HDI PNP 2024-037

Palisades Nuclear Plant
NRC Docket No. 50-255
Renewed Facility Operating License No. DPR-20

Subject: Response to Requests for Additional Information Regarding the Proposed
Reauthorization of Power Operations of Palisades Nuclear Plant under Renewed
Facility Operating License Number DPR-20

GEN-1 Figure 1a

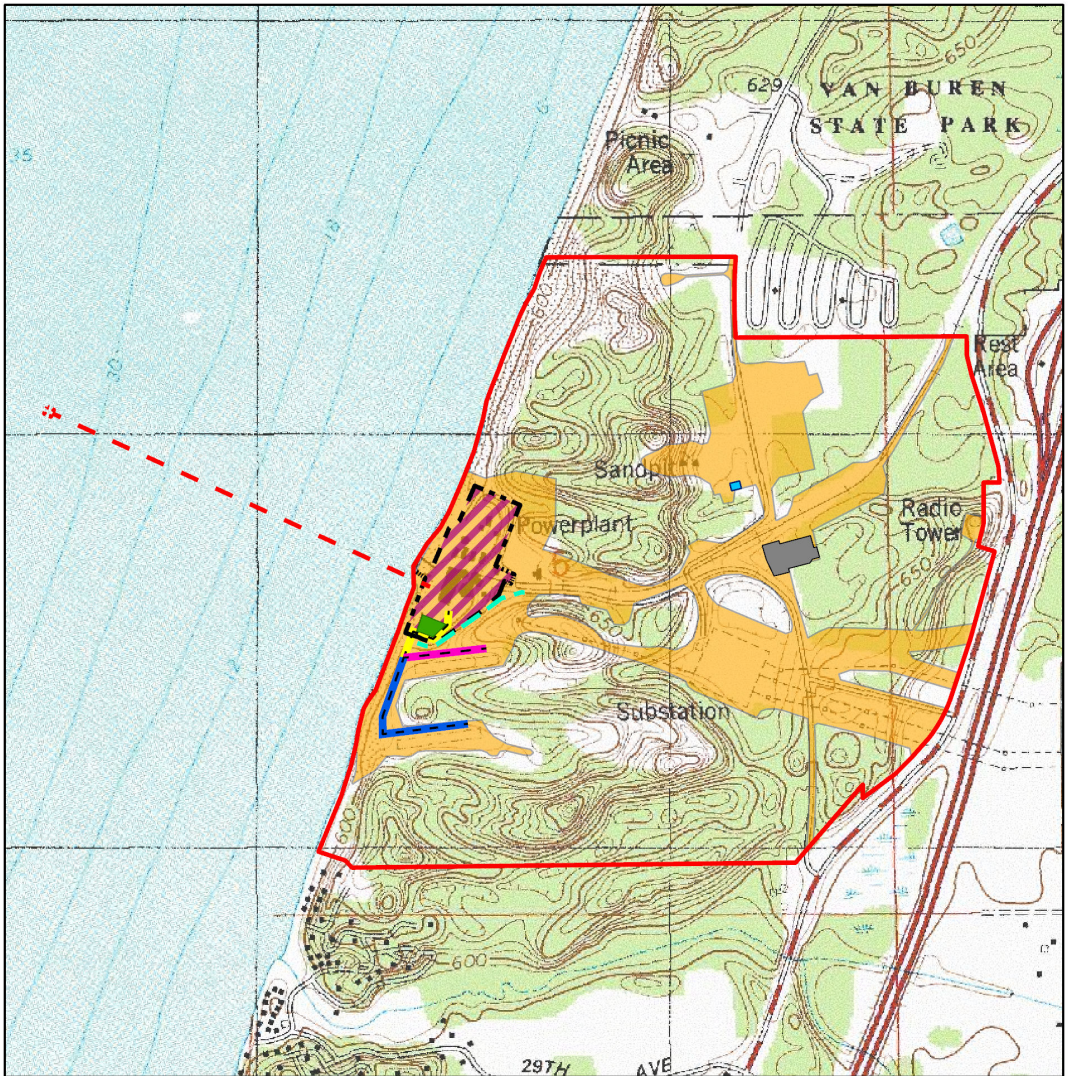
Provide a detailed list of activities—all activities related to the Federal actions—planned for the PNP to support resumption of power operations (planned restart-related activities). Including:

- For any ground disturbing activities, or any refurbishment activities, (e.g., building or demolition, etc.) provide:
 - Location and scheduled start of activity.
 - Number of acres disturbed and depth of disturbance.
 - Whether the disturbance is temporary or permanent.
- Provide any historical construction disturbance photographs and maps detailing the extent of previously disturbed areas or earth disposal areas.
- A figure or drawing indicating location of all planned restart-related activities, including, laydown areas, and extent of ground disturbance on an updated site map.
- Publication-quality files of figures are needed for reproduction in the EA (sized for 8.5 x 11 in. page, resolution at least 300 dpi, in .png or .tif format). The geographic information system or GIS shapefiles that are generated are also needed.

The planned maintenance and upgrade activities are primarily occurring on or inside existing facility structures. The activities are categorized as inside or outside activities. All restart activities in the Restart Activities Tables, Inside and Outside Activities, included in Attachment 1, are planned to start before Palisades returns to power operations. Planned maintenance and upgrade activities that involve land disturbance are identified in the list and shown on GEN-1 Figure 1a provided in Attachment 1. Not depicted on Figure 1a is the installation of mobile

personnel in-processing buildings which will be placed within existing developed areas and the new blast resistant enclosure (security features) which will be located in the Protected Area. Planned maintenance and upgrade activities are also overlaid on a USGS topography map in GEN-1 Figure 1b.

Land disturbance will be within the existing previously developed areas and no additional acreage would be needed based on current plans. Any support areas, such as laydown areas, would also be within existing disturbed areas on the PNP site as shown on GEN-1 Figure 2 provided in Attachment 1. Estimated disturbed acreages for the outside restart activities are presented in the table of Restart Activities provided. All disturbances (occurring within previously disturbed areas) will remain disturbed with exception to any areas which require habitat restoration per the ongoing dune permitting process. GEN-1 Figure 2 shows the approximate boundary of restart activities at PNP which represents the bounding area allowed for projects to use for laydown and actual work. The area within the boundaries is approximately 64 acres.

Attachment 1 - Groundwater Contours – April 25, 2023

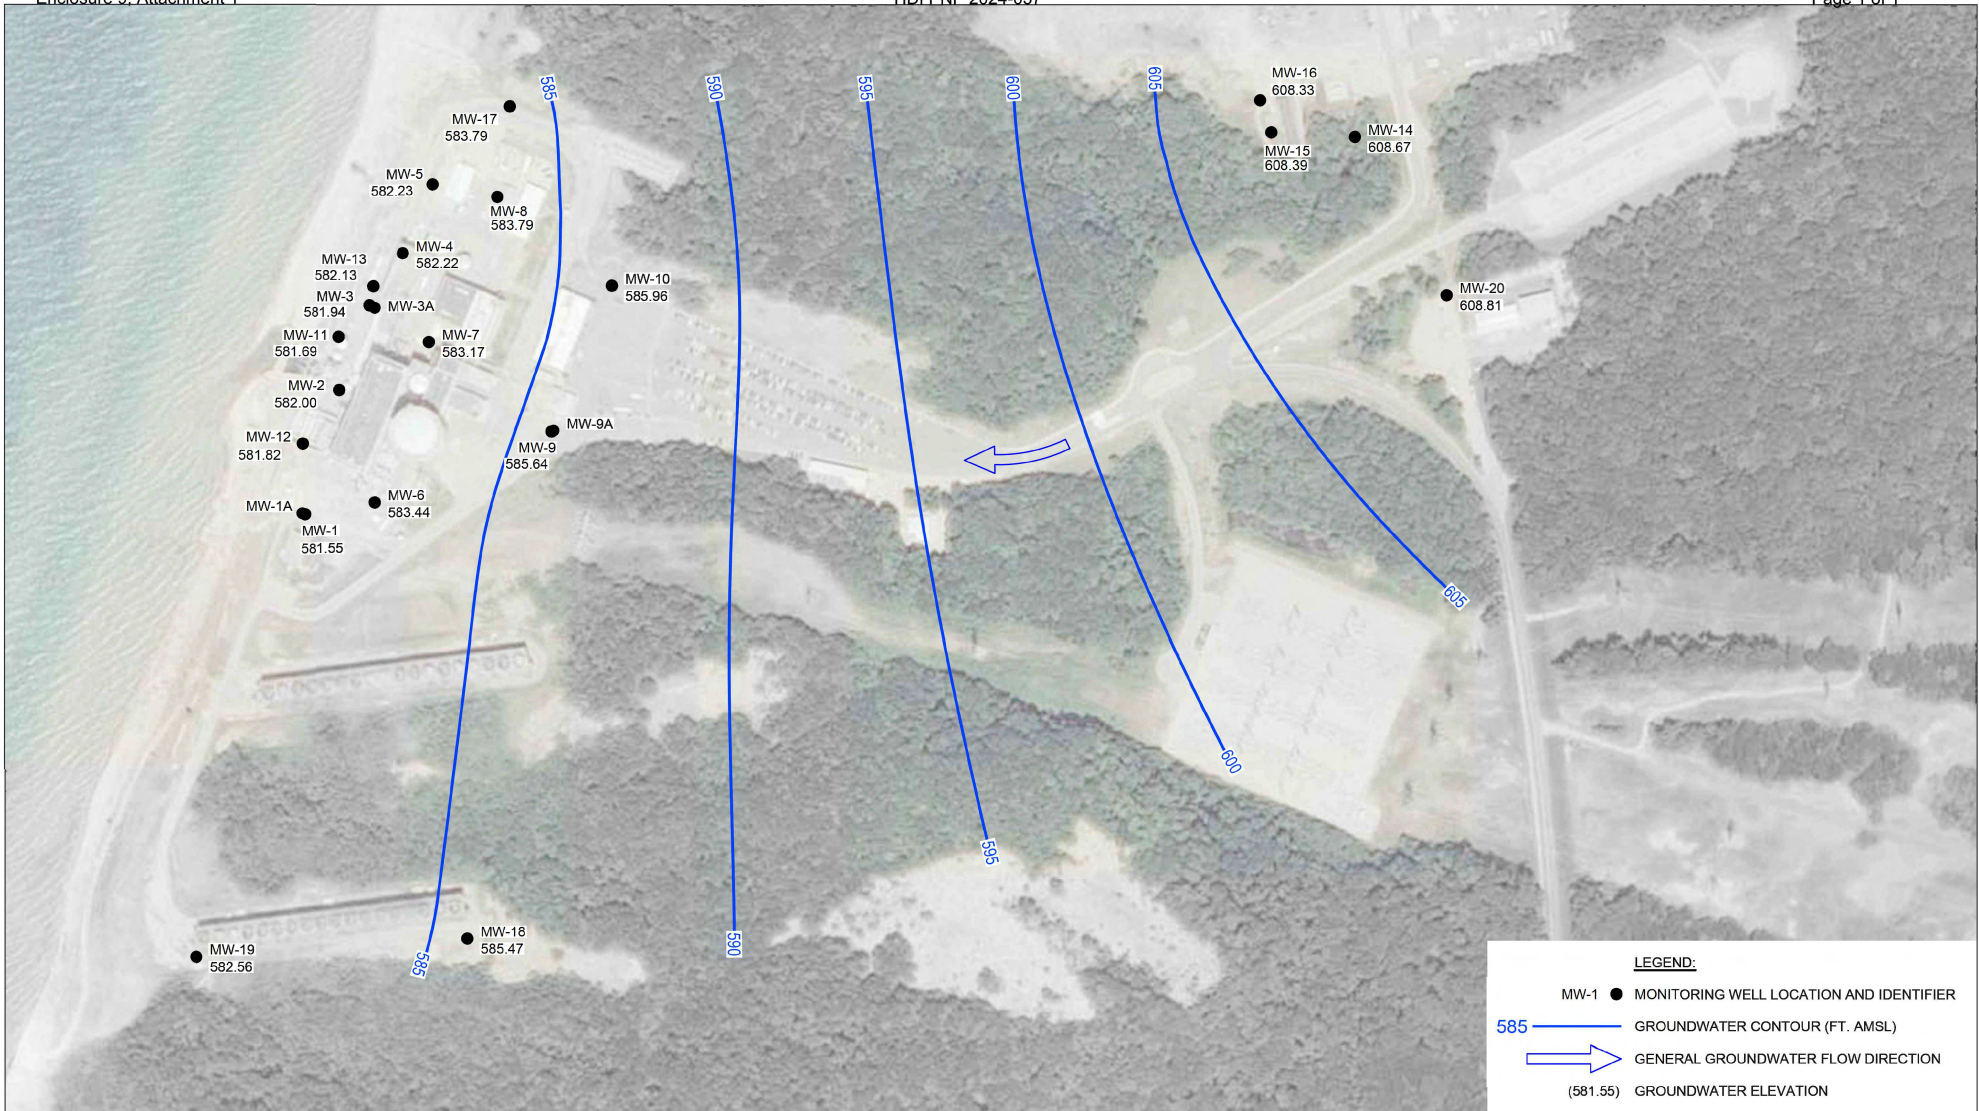
Figure 3.2-1 of Enclosure 2, "*Environmental New and Significant Review Proposed Resumption of Power Operations Palisades Nuclear Plant,*" of HDI's exemption request depicts groundwater contours. Provide the year and month that the elevation data were collected that were used to generate the contours. Provide recent contour maps or groundwater elevation data that capture seasonal variation (if any) of site groundwater levels.

As presented in Section 3.2.1.2 on page 24 of the "*Environmental New and Significant Review Proposed Resumption of Power Operations Palisades Nuclear Plant,*" of the 10 CFR 50.82 Exemption Request (ML23271A140), water level elevation data presented in Figure 3.2-1 were collected in June 2017. The most recent available potentiometric surface map is provided in Attachment 1.
